MONTGOMERY COUNTY HISTORIC PRESERVATION COMMISSION
STAFF REPORT

Address:	7 W Kirke Street., Chevy Chase	Meeting Date:	12/07/2022
Resource:	Contributing Resource Chevy Chase Village Historic District	Report Date:	11/29/2022
Applicant:	Lucy Byrne, Architect	Public Notice:	11/23/2022
Review:	HAWP	Tax Credit:	n/a
Permit No.:	1012774	Staff:	Winnie Cargill
Proposal:	Generator Installation

The applicant proposes to add a 48-kilowatt generator behind the garage.

Figure 2: 1916 Sanborn Fire Insurance Map showing the subject property with Laurel Pkwy to the north.

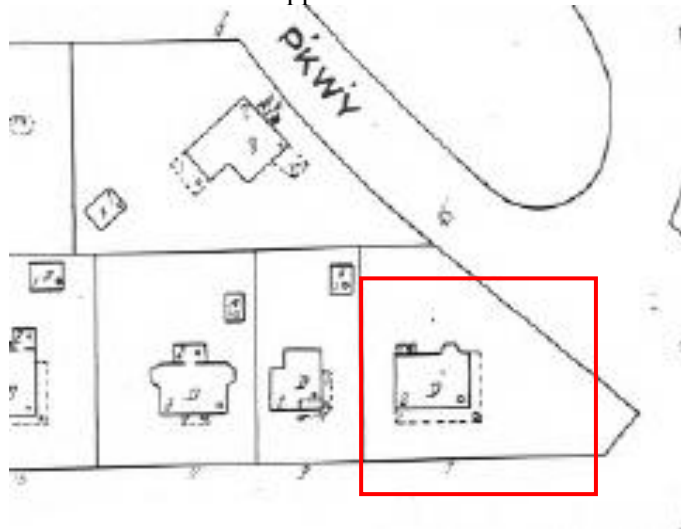
Staff's initial impression at a recent site visit was that the garage was not original to the house. The 1927 Sanborn Fire Insurance Map did not show a garage (typically marked with an “A” for automobile) at the subject property (see below). In 2009 the HPC approved a HAWP to demolish the existing non-historic garage and construct the existing garage.¹

Building Permit Site Plan
and Drainage Plan

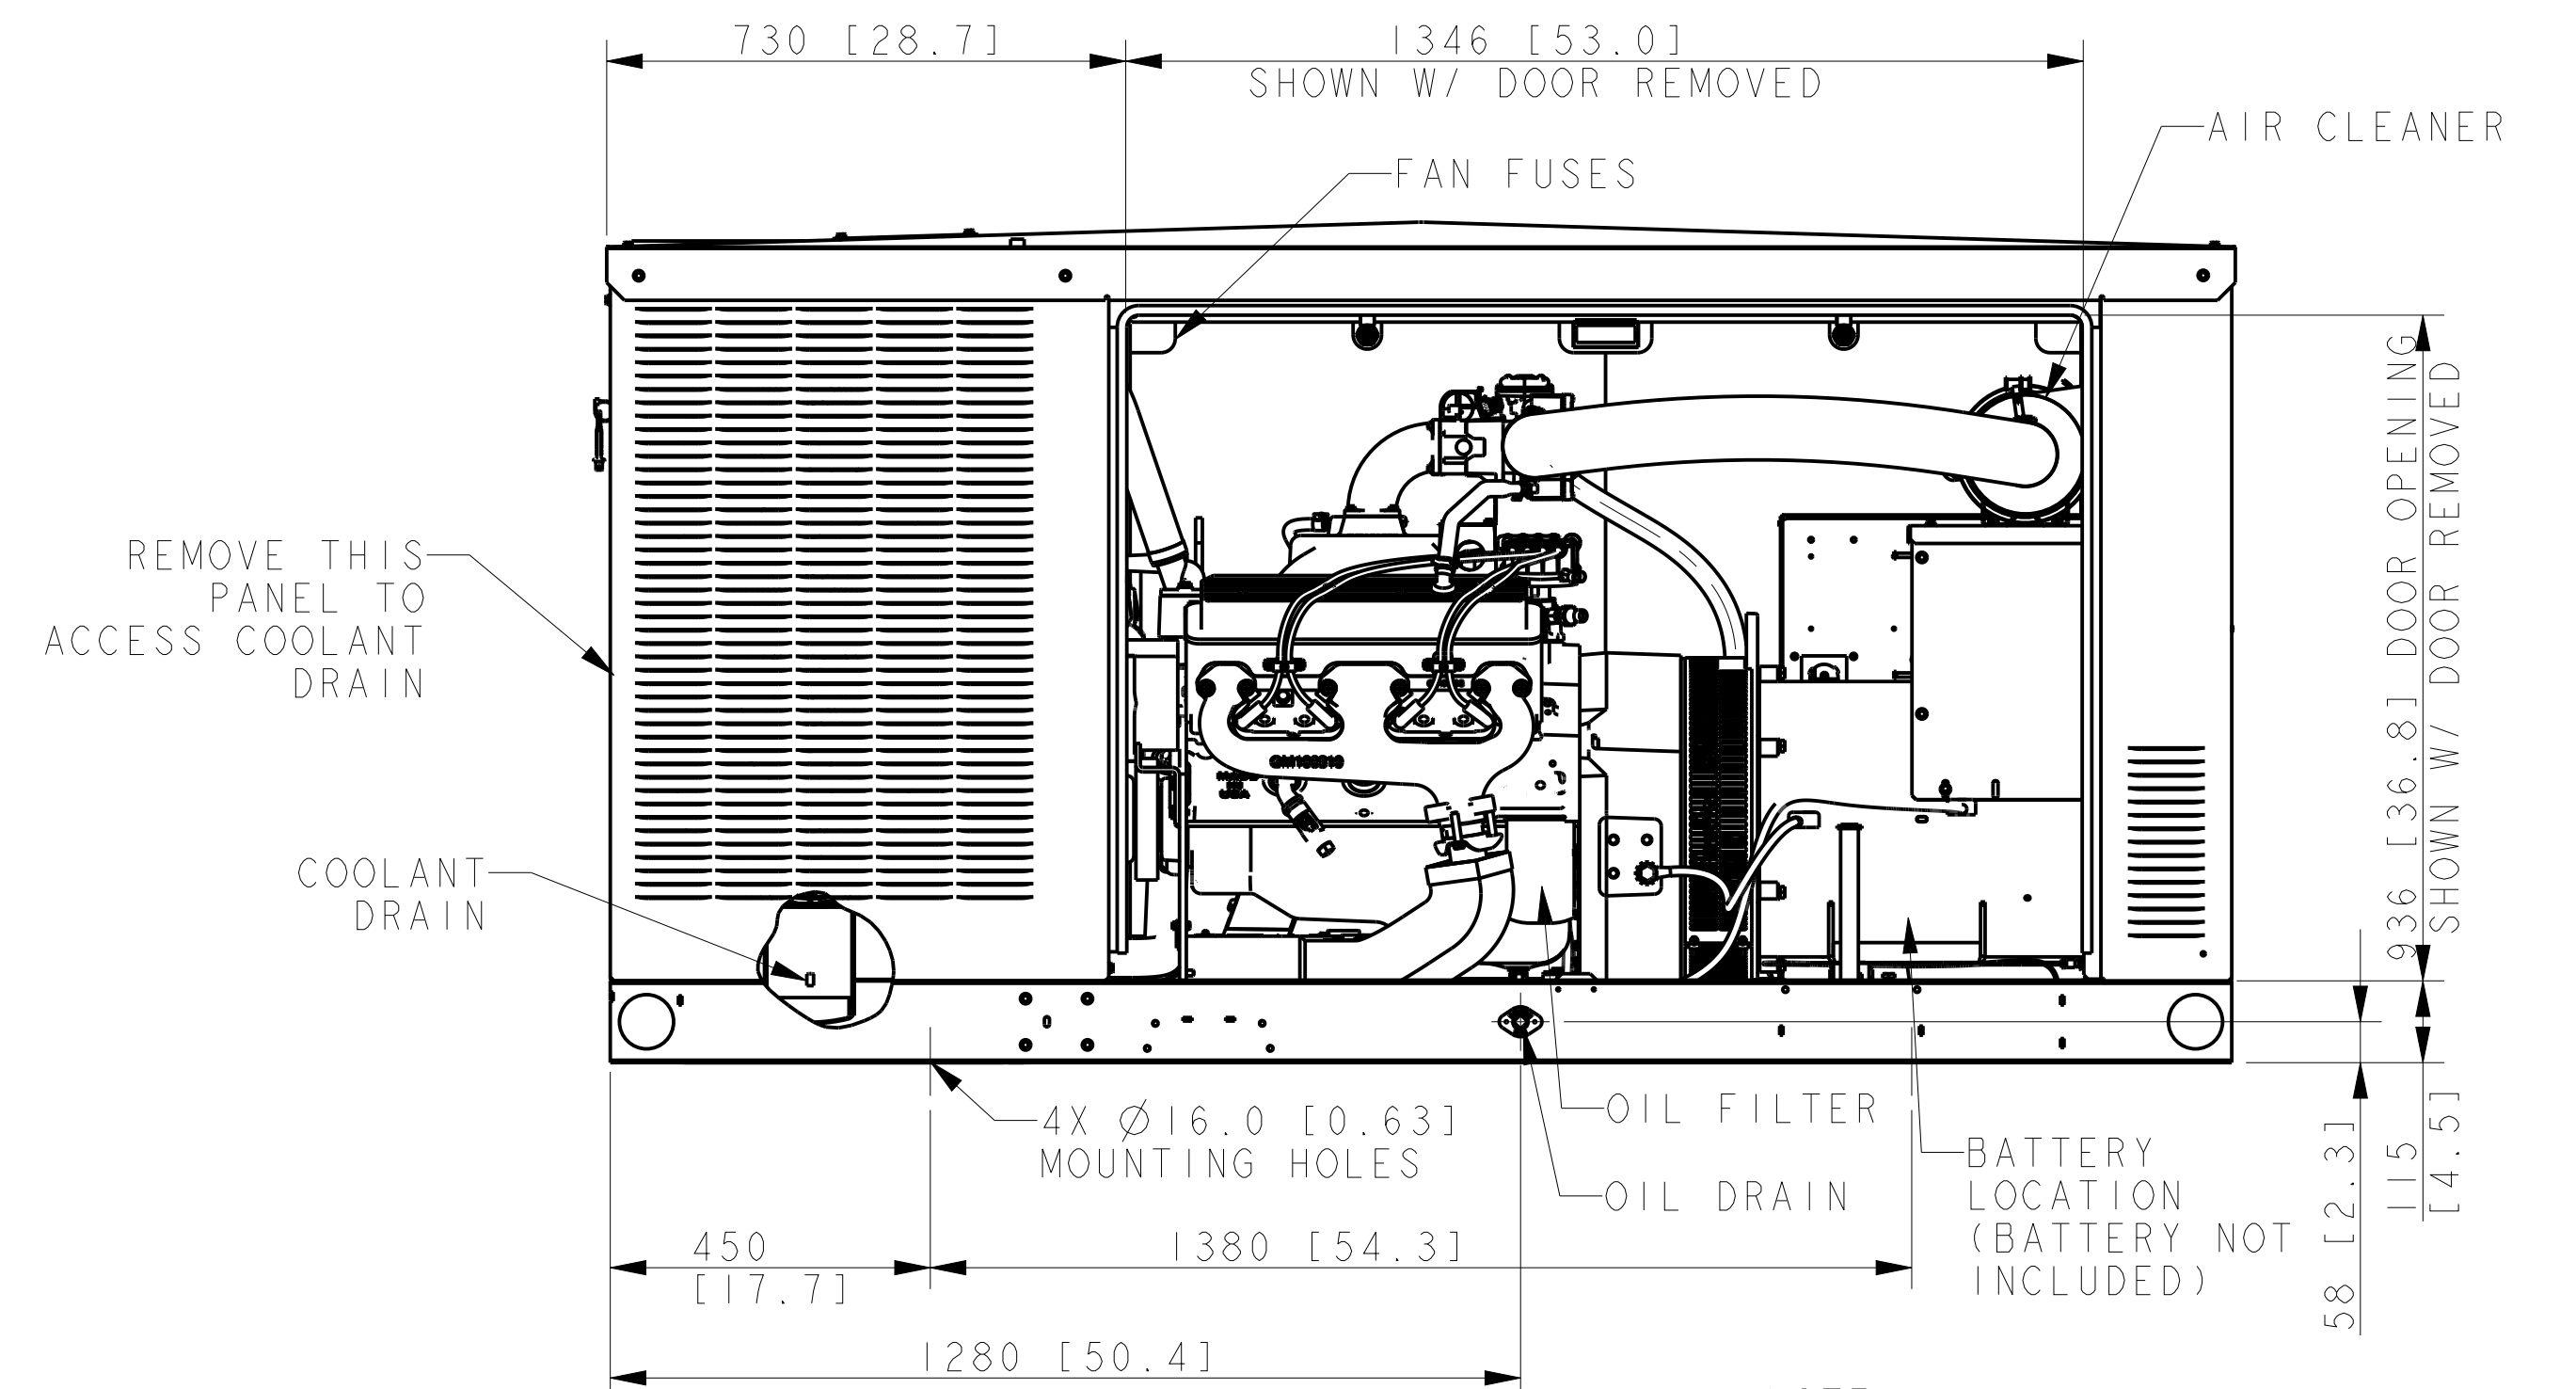
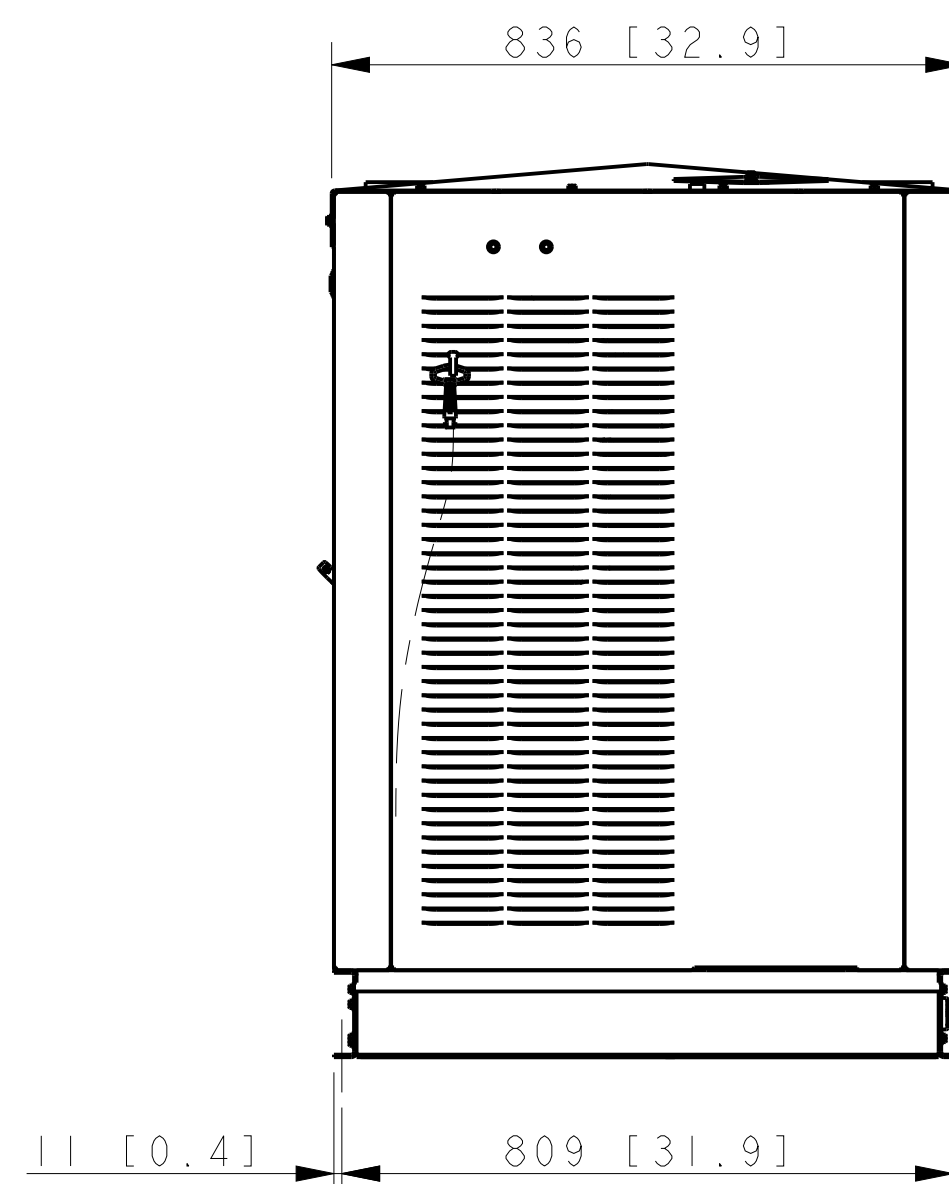
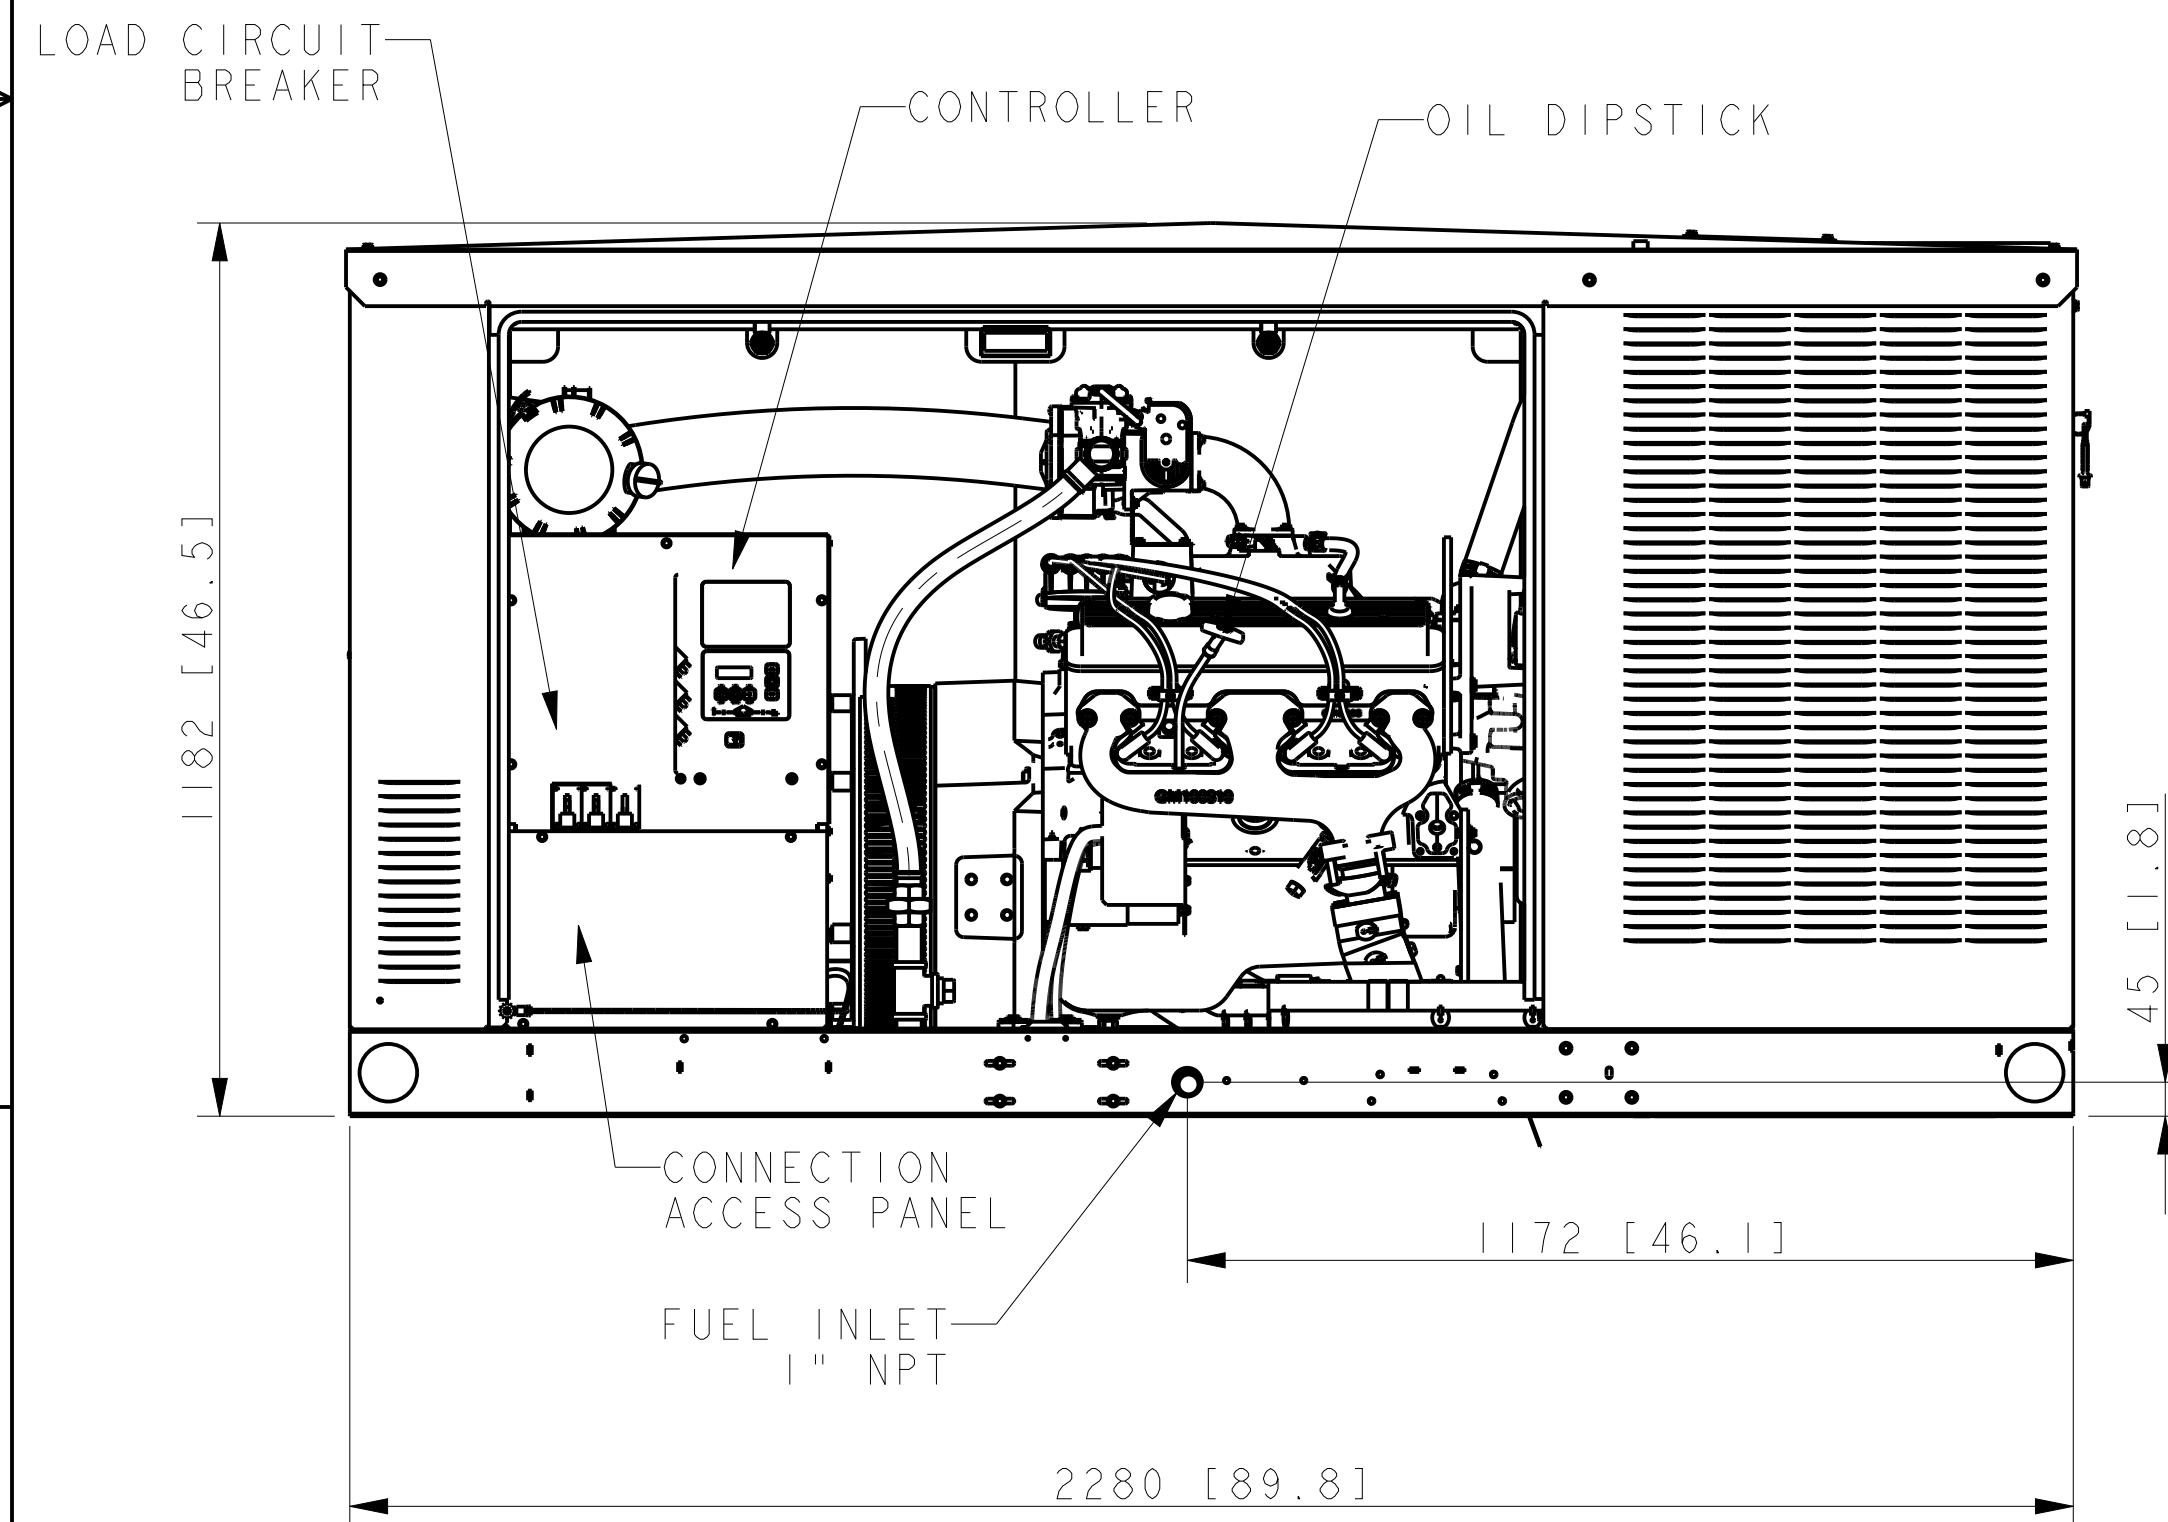
The applicant proposes to install a 48-kilowatt backup generator on a concrete pad to the north side of the garage, in the location of an existing air conditioning unit and water tank. The proposed generator measures 7.48' x 2.74' x 3.875' (seven point four eight feet wide by two point seven four feet by three point eight seventy-five feet tall). The generator will be installed 7' (seven feet) from the left (east) property line and 5.8' (five point eight feet) to the south of the north property line.

Staff finds the generator will not be at all visible from the W. Kirke St. right-of-way, because its view is blocked by the garage. From Lenox Pkwy., views of the generator will be obscured by the existing privacy fence. However, in the absence of that fence and vegetation, the generator would be visible from Lenox Parkway.

Staff finds that the proposed generator is entitled to a very lenient level of scrutiny based on the *Design Guideline* policy for alterations that are not at all visible from the right-of-way. Staff additionally finds the proposed generator is far enough from the adjacent historic houses that it will not have a visual impact on their historic character. Staff finds, the proposed generator is not out of scale with the subject property and surrounding streetscape and should be approved under the *Guidelines* as a matter of course; and 24A-8(d).

Staff further recommends the applicant continue to maintain or expand the greenery surrounding the generator location to mitigate the sound and exhaust when it is in operation. Because the *Guidelines* require HP review in the absence of any vegetation, this is only a recommended course of action and requires no further review by the HPC.

Staff recommends that the Commission **approve** the HAWP application under the Criteria for Issuance in Chapter 24A-8(b)(2) and (d), having found that the proposal will not substantially alter the exterior features of the historic resource and is compatible in character with the district and the purposes of the *Chevy Chase Village Historic District Guidelines* ;
